Access Compliance Report

Public Rights-of-Way

Intersection ID: 30027	Main Street: BRIGHTHAVEN_LN	Cross Street: SMOOTHSTONE_LN	Location: NE
ADA ID: EA0C6F17AD28	Ramp Type: PerpDiag	Initial Pass/Fail: Fail	Overall Compliance: No
Severity Score: 50			
Codes/Mitigation Info/Possible Solution		Field Measurements/Component Compliance

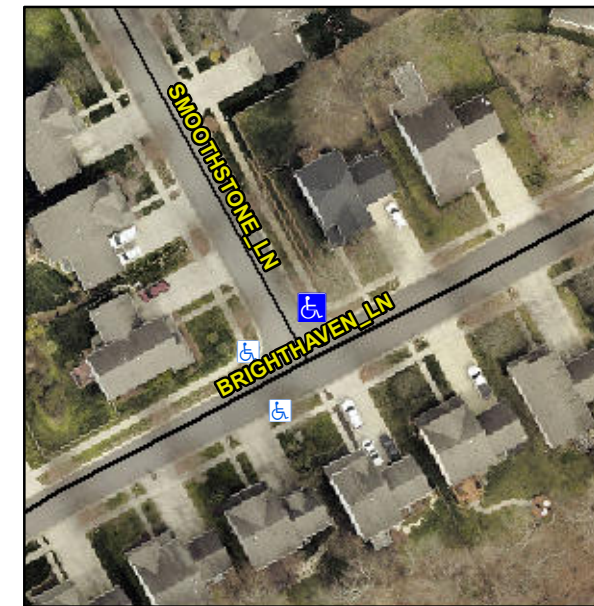
Not Found, R304.2.2, R304.5.3

Compliance	Description	Data	Compliance	Description	Data
N/A	Ramp Length (in)	41.0	No	Ramp Slope (%)	16.6
Yes	Ramp Width (in)	48.0	No	Ramp XSlope (%)	8.4
N/A	Flare Type LT	N/A	N/A	Flare Type RT	N/A
N/A	Flare Slope LT (%)	N/A	N/A	Flare Slope RT (%)	N/A
N/A	Flare Traversable LT?	N/A	N/A	Flare Traversable RT?	N/A
N/A	Landing Length (in)	N/A	N/A	DWS Provided?	N/A
N/A	Landing Width (in)	N/A	N/A	DWS Contrast?	N/A
N/A	Landing Slope (%)	N/A	N/A	DWS Length (in)	N/A
N/A	Landing X Slope (%)	N/A	N/A	DWS Full Width?	N/A
N/A	Landing Curb? (Y/N)	N/A	N/A	DWS Offset (in)	N/A
N/A	Shared Landing?	N/A			
N/A	Gutter Ponding?	N/A	N/A	Gutter Slope (%)	N/A
N/A	Gutter Lip Ht (in)	N/A	N/A	Gutter X Slope (%)	N/A
N/A	Painted X Walk1?	No	N/A	Painted X Walk2?	No
	X Walk 1 Direction	To W		X Walk 2 Direction	To S
N/A	X Walk 1 Width (in)	N/A	N/A	X Walk 2 Width (in)	N/A
	X Walk 1 Slope (%)	0.4		X Walk 2 Slope (%)	6.6
	X Walk 1 X Slope (%)	6.1		X Walk 2 X Slope (%)	9.5

Remove & Replace Curb Ramp With Two New Directional Ramps or Equivalent.
